Access Compliance Report

Public Rights-of-Way

(Curb Ramps)

Intersection ID: 10918	Main Street: MATHESON_AV	Cross Street: HOLT_ST	Location: S
ADA ID: 621503F103F7	Ramp Type: PerpDiag	Initial Pass/Fail: Fail	Overall Compliance: No
Codes/Mitigation Info/Possible Solution		Field Measurements/Component Compliance	
Severity Score: 26.25

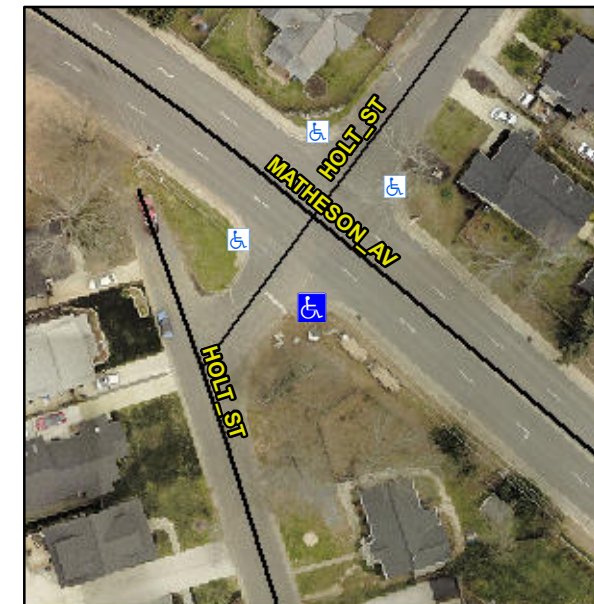
Not Found, R304.2.2, R304.5.3

Compliance	Description	Data	Compliance	Description	Data
N/A	Ramp Length (in)	61.0	No	Ramp Slope (%)	14.9
Yes	Ramp Width (in)	65.0	No	Ramp XSlope (%)	4.2
N/A	Flare Type LT	N/A	N/A	Flare Type RT	N/A
N/A	Flare Slope LT (%)	N/A	N/A	Flare Slope RT (%)	N/A
N/A	Flare Traversable LT?	N/A	N/A	Flare Traversable RT?	N/A
N/A	Landing Length (in)	N/A	N/A	DWS Provided?	N/A
N/A	Landing Width (in)	N/A	N/A	DWS Contrast?	N/A
N/A	Landing Slope (%)	N/A	N/A	DWS Length (in)	N/A
N/A	Landing X Slope (%)	N/A	N/A	DWS Full Width?	N/A
N/A	Landing Curb? (Y/N)	N/A	N/A	DWS Offset (in)	N/A
N/A	Shared Landing?	N/A			
N/A	Gutter Ponding?	N/A	N/A	Gutter Slope (%)	N/A
N/A	Gutter Lip Ht (in)	N/A	N/A	Gutter X Slope (%)	N/A
N/A	Painted X Walk1?	No	N/A	Painted X Walk2?	No
	X Walk 1 Direction	To NE		X Walk 2 Direction	To NW
N/A	X Walk 1 Width (in)	N/A	N/A	X Walk 2 Width (in)	N/A
	X Walk 1 Slope (%)	4.0		X Walk 2 Slope (%)	0.5
	X Walk 1 X Slope (%)	2.1		X Walk 2 X Slope (%)	5.1

Remove & Replace Curb Ramp With Two New Directional Ramps or Equivalent.
